TECHNICAL RESPONSE TO HCC HIGHWAYS COMMENTS

Ridge and Partners have been commissioned to respond to the Road Safety Audit undertaken by Fenley (March 2026) as part of the S278 Technical Approval Process.

Road Safety Audit Report

Proposed Continuation of Coldharbour Farm Road Emsworth

TITLE: S278 TRACKING

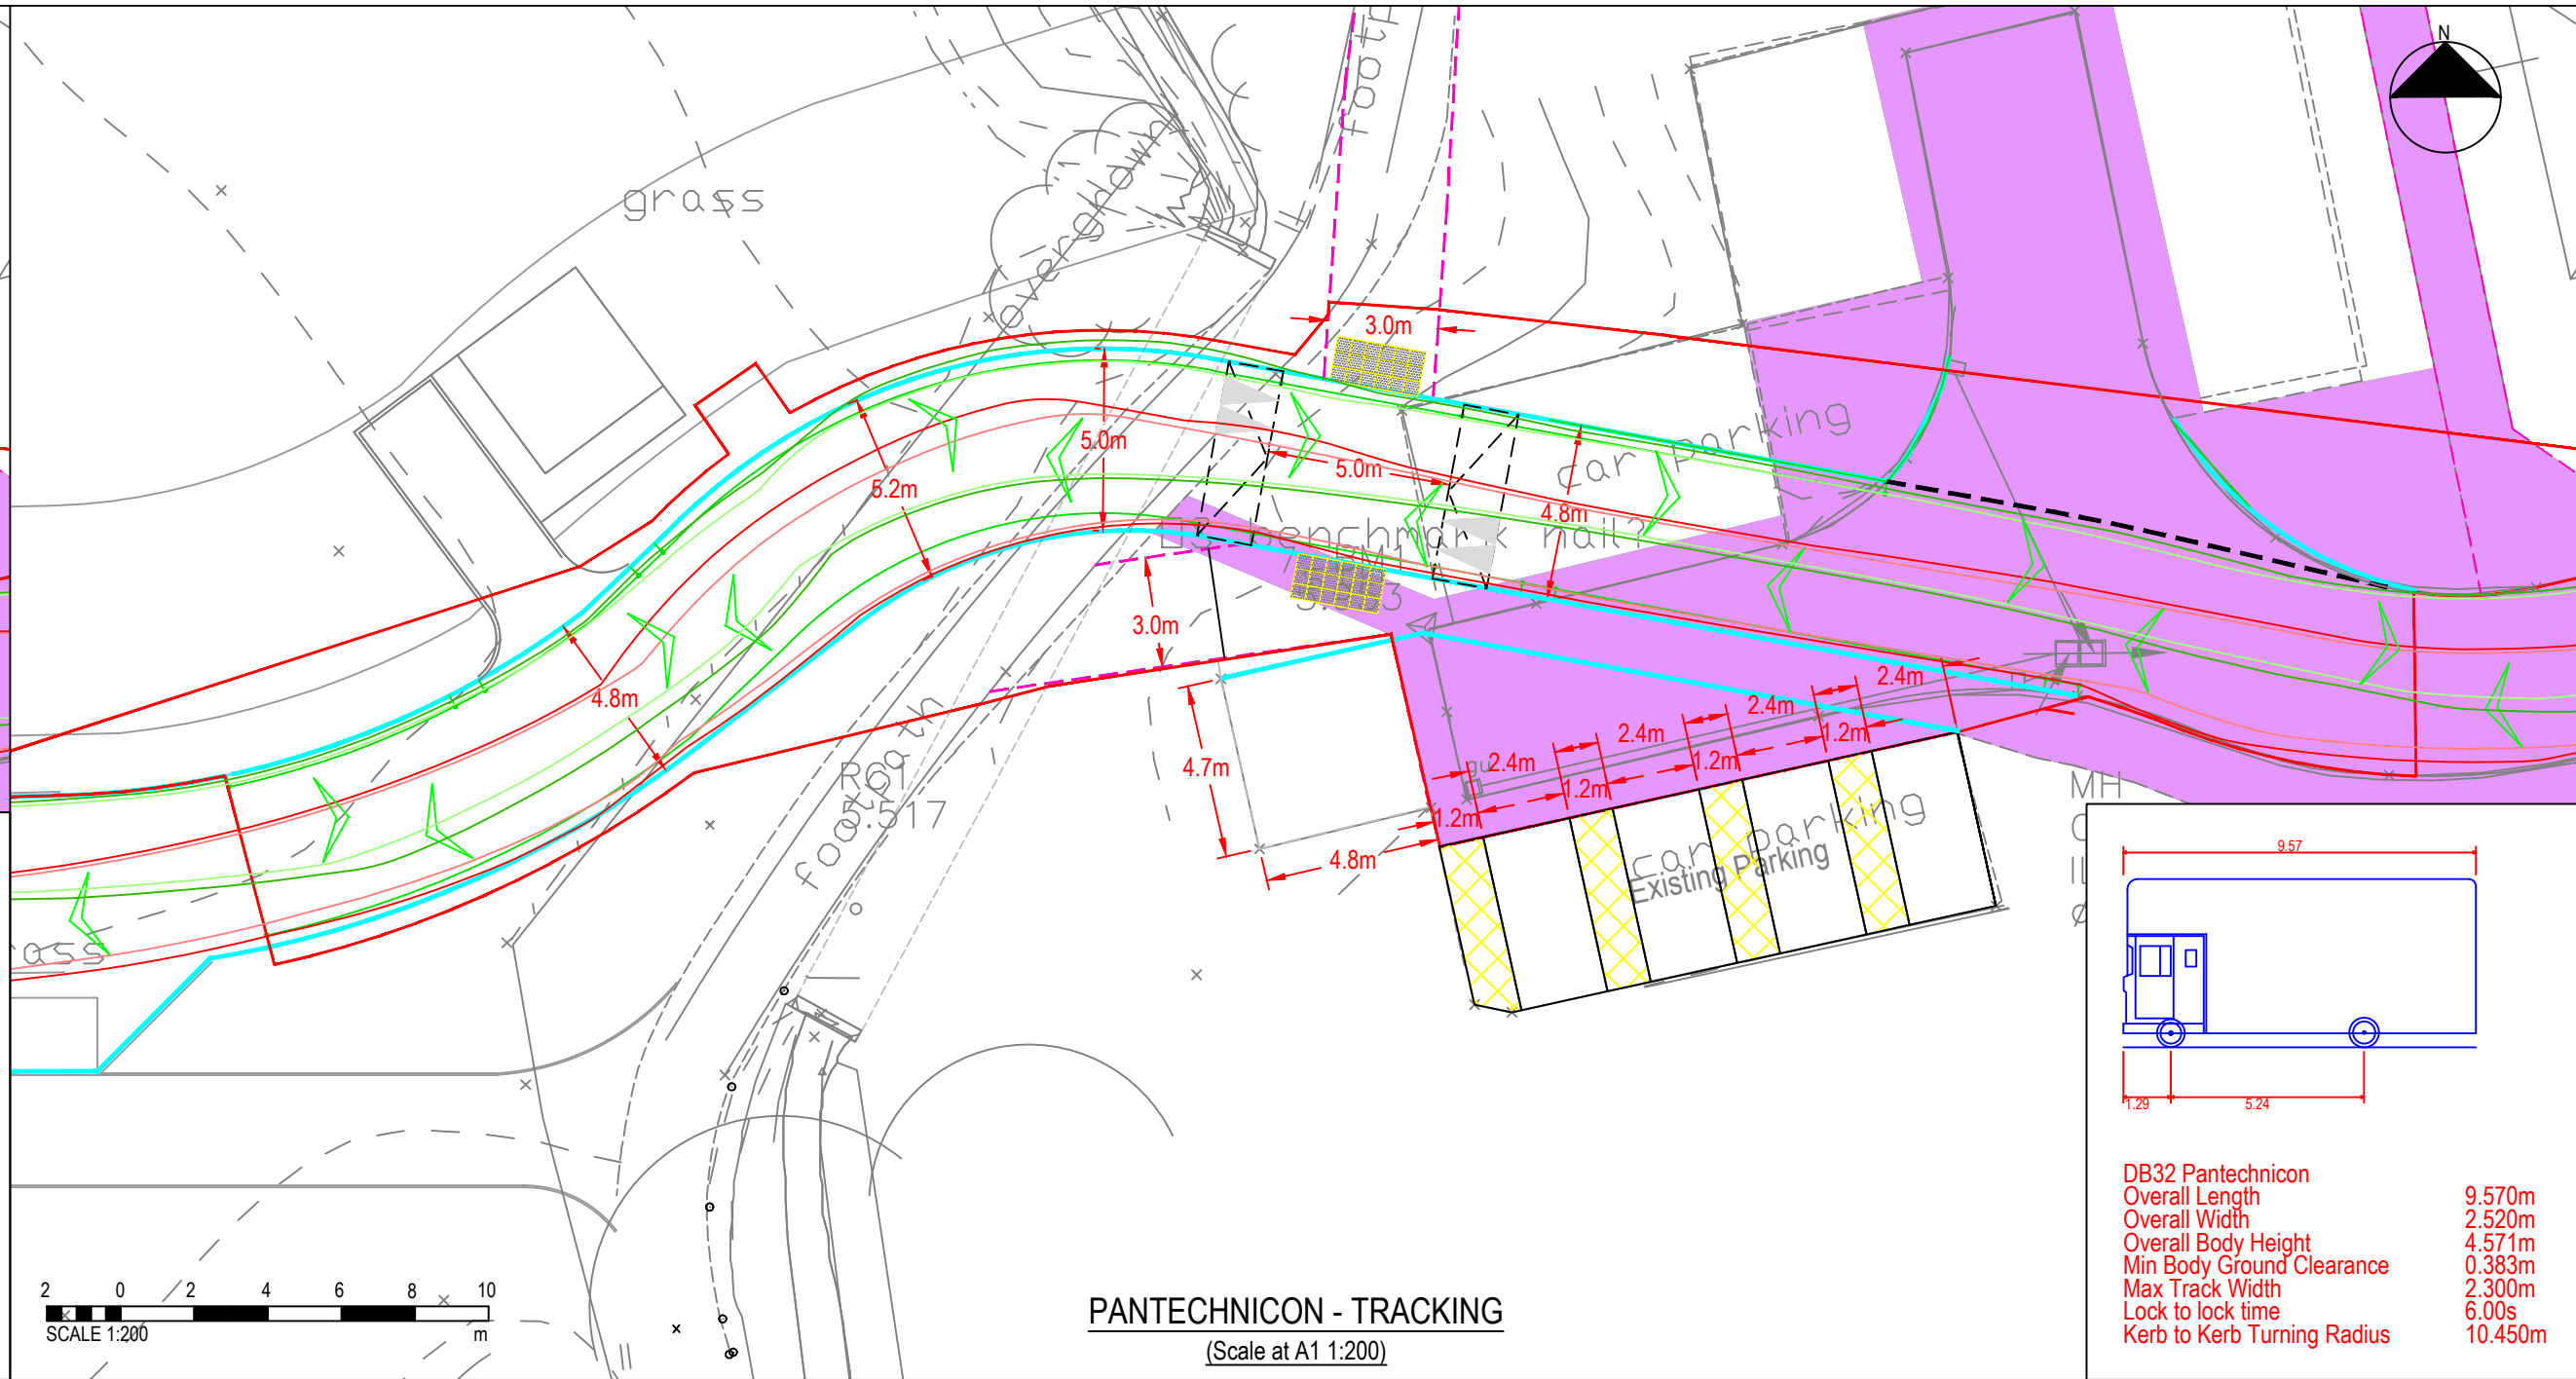
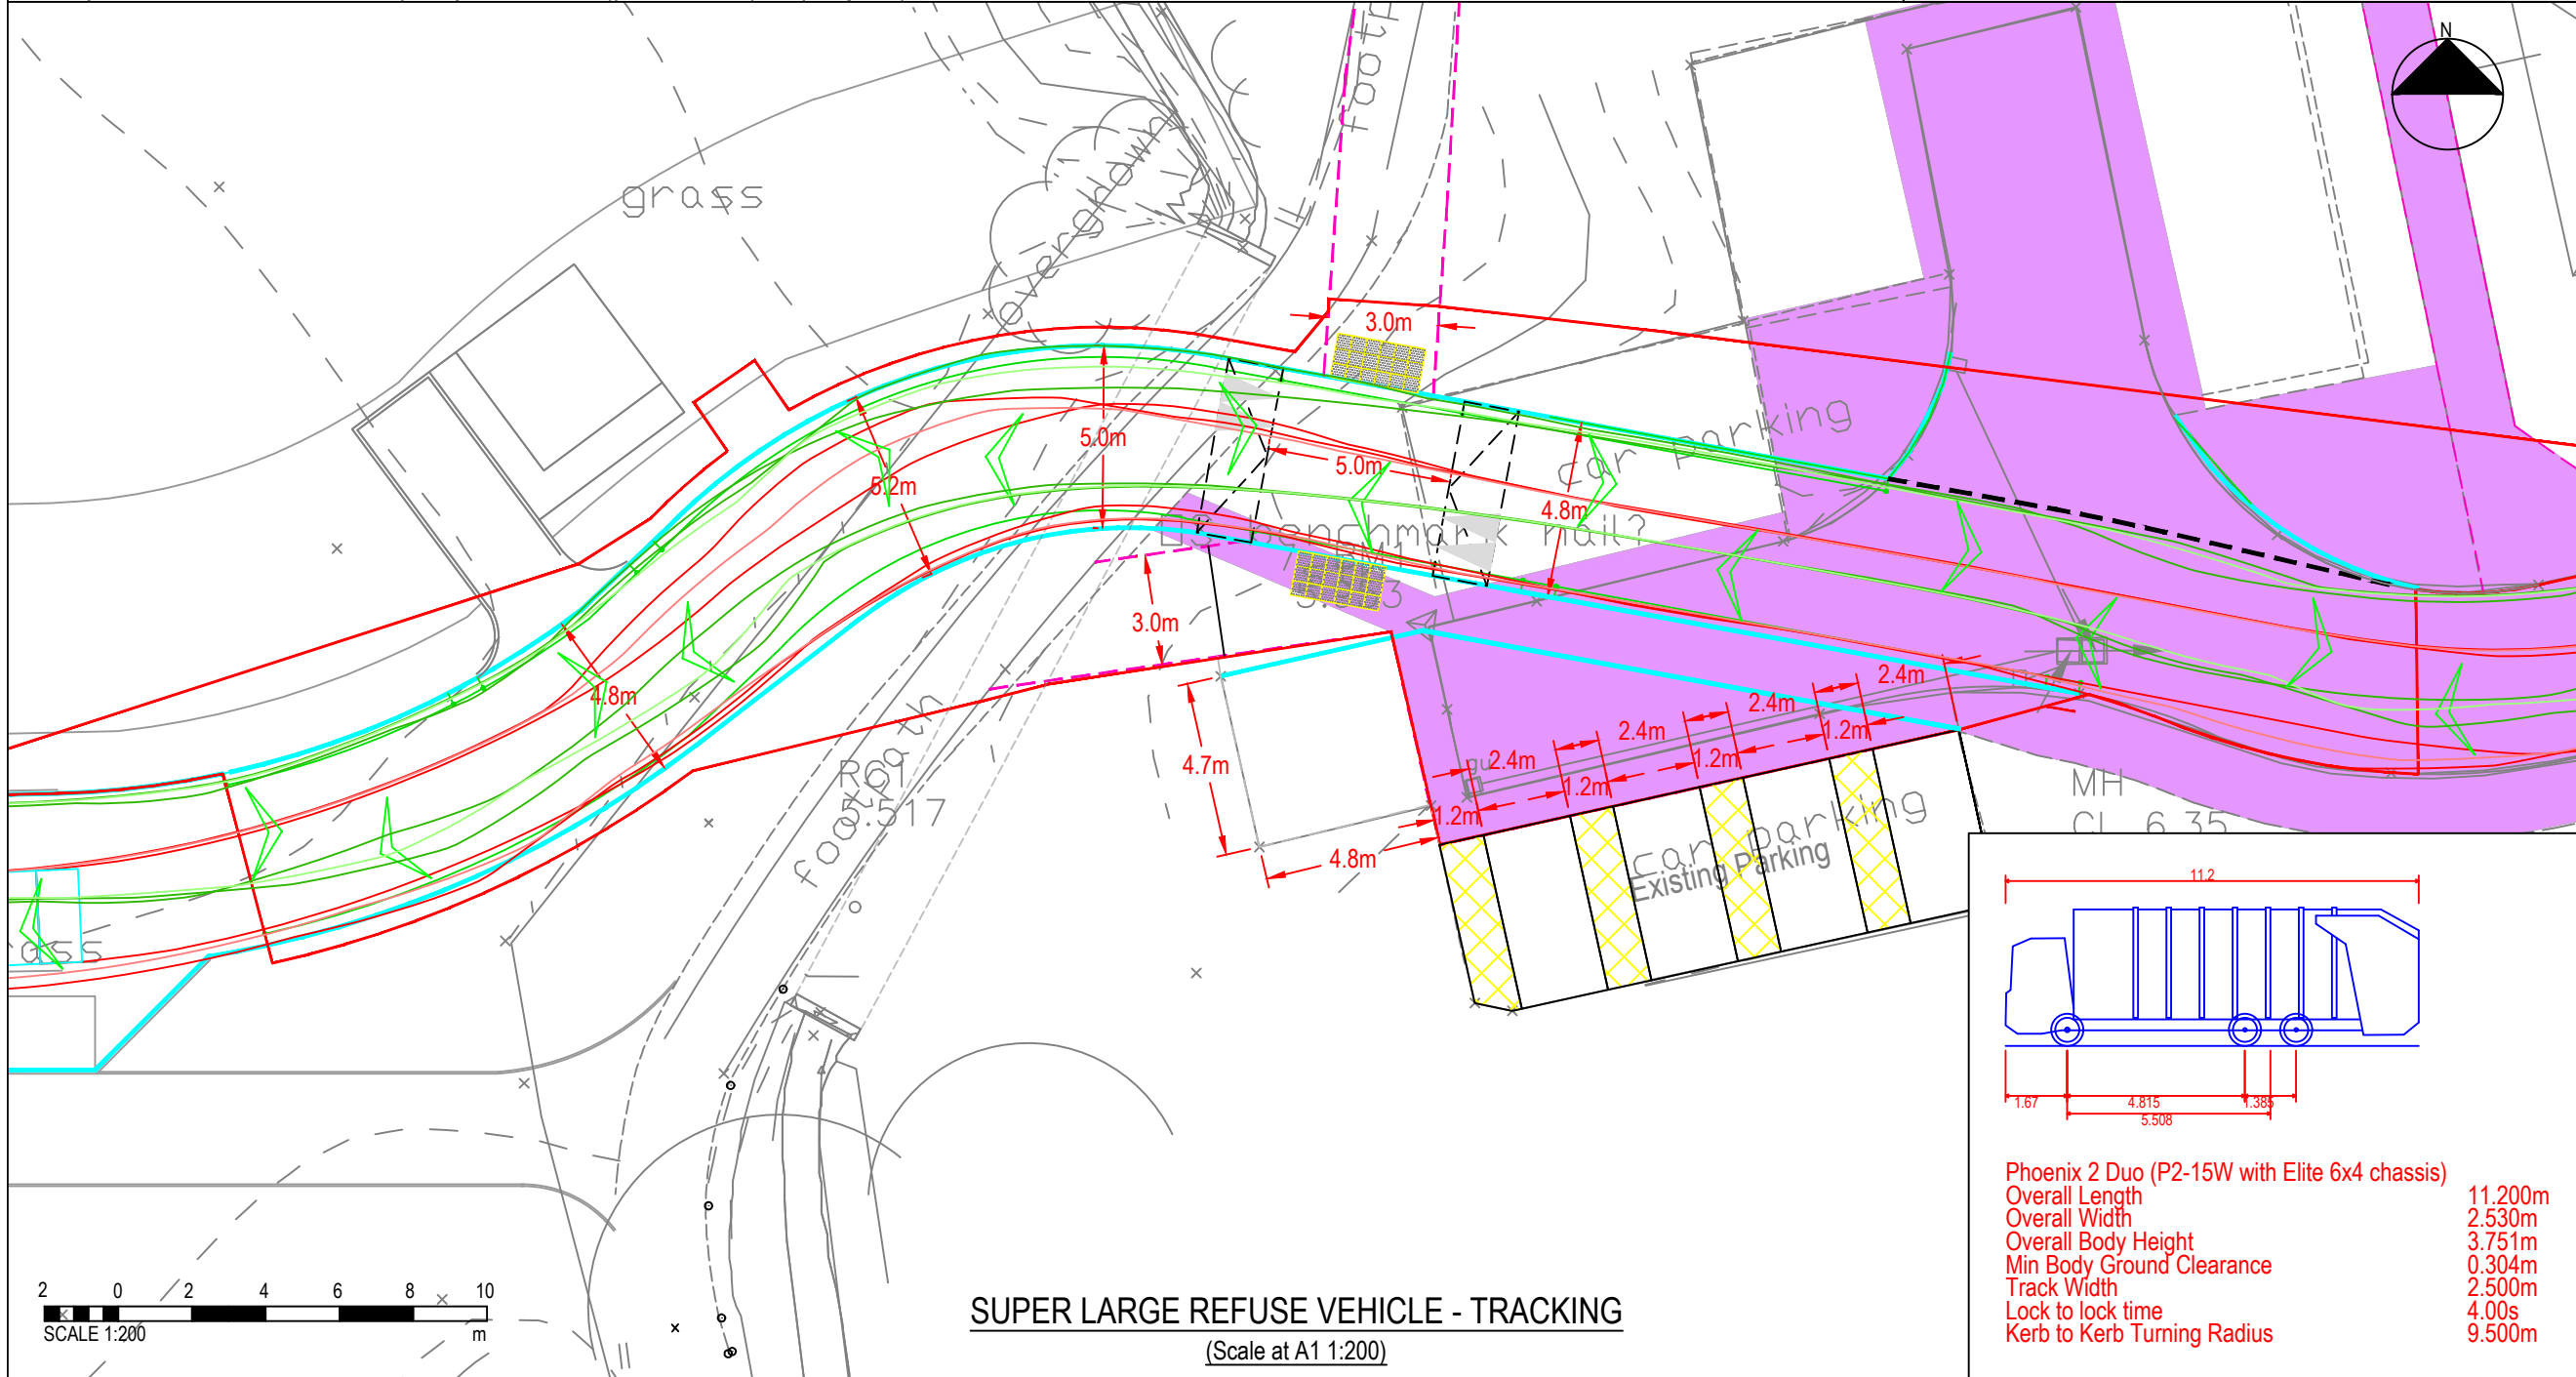
B.1.1 – Alignment may not be adequate for two-way car / LGV movements. It is recommended that the carriageway is adequate for cars and LGVs to pass one another.

We have provided updated tracking Drawing 23339-JUBB-XX-XX-DR-X-001200 REV C4 that shows in the bottom right that cars can pass each other.
